GFA AIRWORTHINESS DIRECTIVE

TYPE AFFECTED: JANUS, JANUS B, JANUS C, JANUS Ce (TCDS 295)
Ser Nos: 1 to 307.
JANUS CM (TCDS 809) Ser Nos: 1 to 37
JANUS CT (TCDS 809) Ser Nos: 1 to 22
NIMBUS-3D (TCDS 373) Ser Nos: 1, 1/3, 2 to 14.
NIMBUS-3DT (TCDS 847) Ser Nos: 1 to 63.
NIMBUS-3DM (TCDS 847) Ser Nos: 1 to 27.

SUBJECT: Flight Controls:- Elevator control system.

SCHEMPP-HIRTH Flugzeugbau GmbH. Kirchheim/Teck	Technical Note No. 295-30 / 373-9 809-16 / 847-9	Page: 01 No. of pages: 03
<p><u>SUBJECT:</u></p> <p><u>AFFECTED:</u></p> <p><u>URGENCY:</u></p> <p><u>REASON:</u></p>	<p>Elevator control system</p> <ul style="list-style-type: none"> - Sailplane model (ATC No. 295) Janus, Janus B, Janus C, Janus Ce S/N 1 through 307 - Sailplane model (ATC No. 373) Nimbus-3D S/N 1, 1/3, 2 through 14 - Powered sailplane model (ATC No. 809) Janus CM S/N 1 through 37 - Powered sailplane model (ATC No. 847) Nimbus-3DT S/N 1 through 63 Nimbus-3DM S/N 1 through 27 <p><u>Action 1:</u> Prior to further flights!</p> <p><u>Action 2</u> <u>and the following:</u> On the occasion of the next annual inspection, but not later than March 31st, 2005</p> <p>On a Janus Ce with 5872 flight hours a break of the attachm

Reinforcement
Front stick control attachment

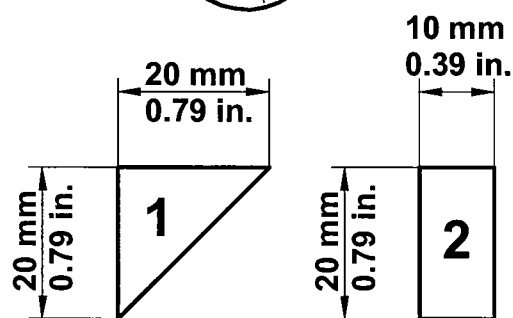
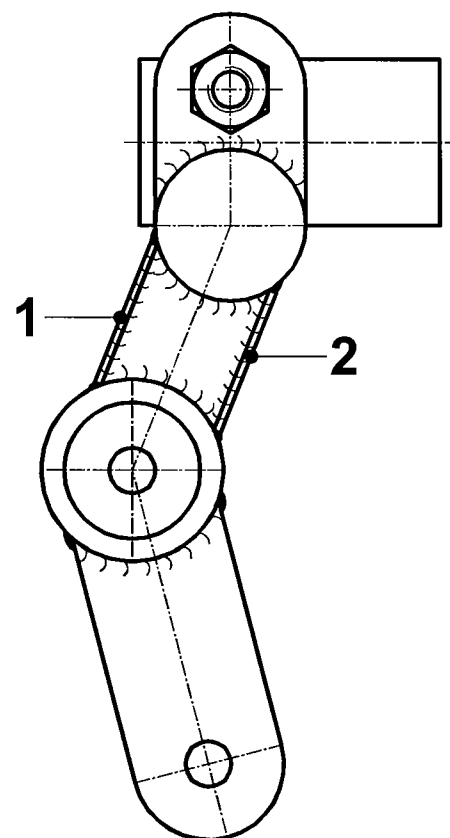
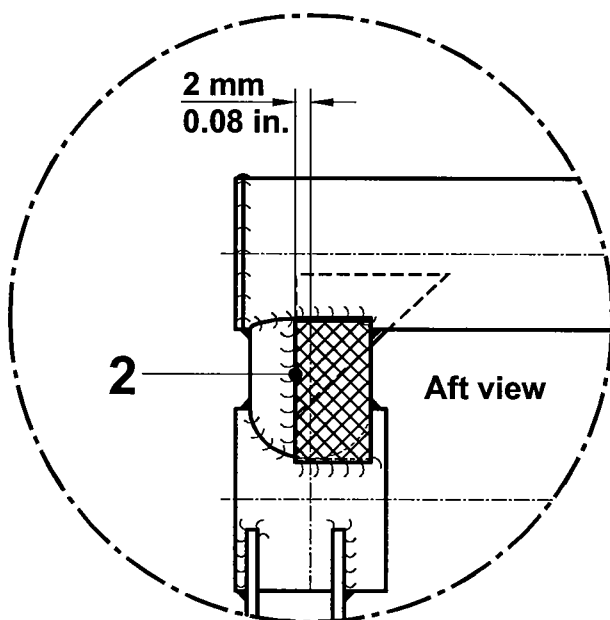
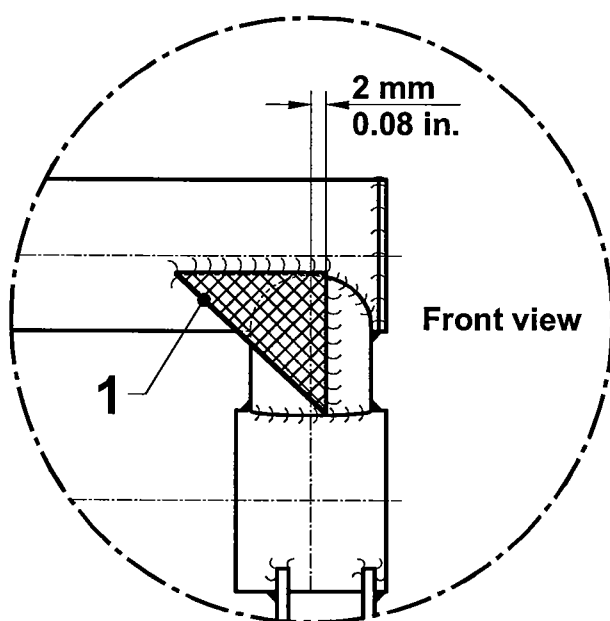
2. Not reinforced outer attachments of the stick control in the front and aft seat must be reinforced in accordance with the instructions in the appendix.

s=1 mm (0.04 in.)
Steel plate quality: 1.7734.4

Welding procedure: WIG
Welding addition material: 1.7734.2
